Development Facilitation Team (DFT) – Review Comments

DRB Project No: PR-2020-003484 Date: 06/14/2023 Agenda Item: #4 Zone Atlas Page: E-10

Location: Mojave St NW between Unser Blvd and Tesuque Dr.

Application For: SD-2023-00048 – PRELIMINARY PLAT (DHO)

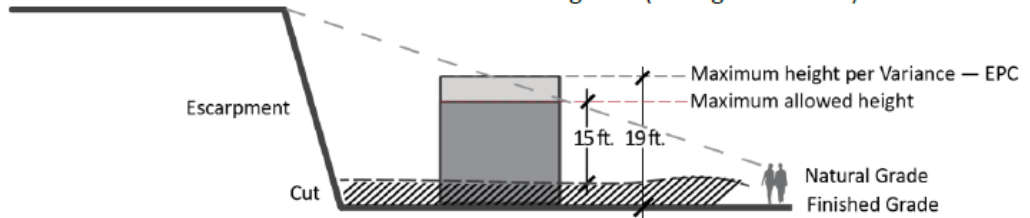
IDO 3-6(E) The parcels are in the VPO-2 Height Restricted Sub Area. Identify the allowable structure height vis a vis grading plan. 'Building and/or structure height shall not exceed 15 feet, as measured from natural grade.'

~~*Show height measurements from finished grade and natural grade. *Clarify if standards are being met.~~

- ✓ The applicant has shown height measurements from finished grade and natural grade and established maximum building heights that do not exceed 15 feet.

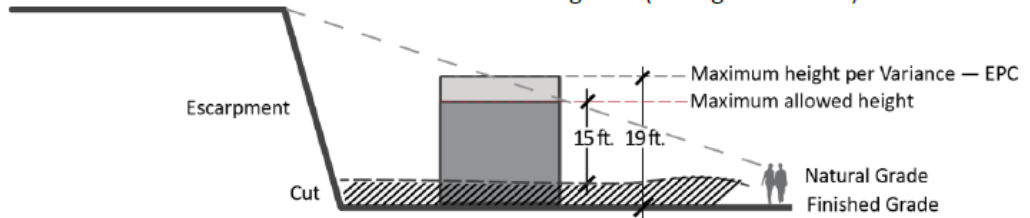
IDO 3-6(E) The parcels are in the VPO-2 Height Restricted Sub Area. Identify the allowable structure height vis a vis grading plan. 'Building and/or structure height shall not exceed 15 feet, as measured from natural grade.'

~~*Show height measurements from finished grade and natural grade. *Clarify if standards are being met.~~

- ✓ The applicant has shown height measurements from finished grade and natural grade and established maximum building heights that do not exceed 15 feet.
